UNITED STATES
DEPARTMENT OF THE INTERIOR
BUREAU OF LAND MANAGEMENTFORM APPROVED
OMB NO. 1004-0137
Expires: January 31, 2018**SUNDRY NOTICES AND REPORTS ON WELLS**
Do not use this form for proposals to drill or to re-enter an abandoned well. Use form 3160-3 (APD) for such proposals.**SUBMIT IN TRIPLICATE - Other instructions on page 2**

XTO Permian Operating, LLC requests permission to make the following changes to the APD:

WELL LOCATION AND ACREAGE DEDICATION PLAT

API # 30-015-46377			
Operator Name: XTO PERMIAN OPERATING, LLC		Property Name: James Ranch Unit DI 11 WHITLASH	Well Number 251H

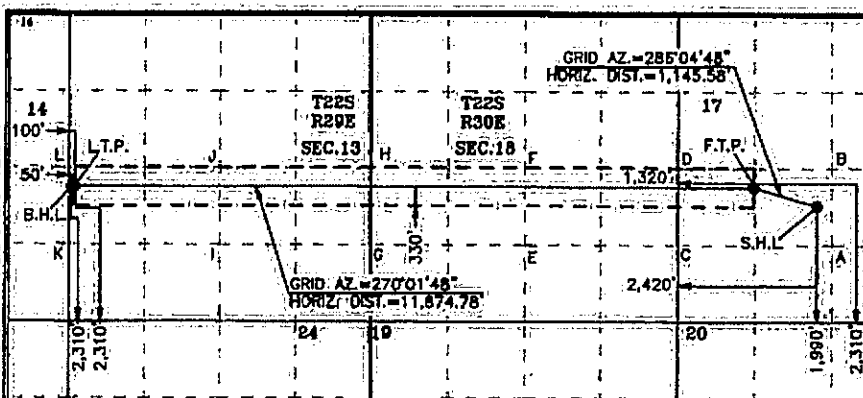
Change SHL from 2040' FSL & 2430' FWL to 1990' FSL & 2420' FWL. No surface disturbance.

Change BHL from 660' FSL & 200' FWL to 2310' FSL & 50' FWL.

UL or lot no.	Section	Township	Range	Lot Idn	Feet from the	North/South line	Feet from the	East/West line	County
K	17	22S	30 E		1,990	SOUTH	2,420	WEST	EDDY

UL or lot no.	Section	Township	Range	Lot Idn	Feet from the	North/South line	Feet from the	East/West line	County
L	13	22 S	29 E		2,310	SOUTH	50	WEST	EDDY
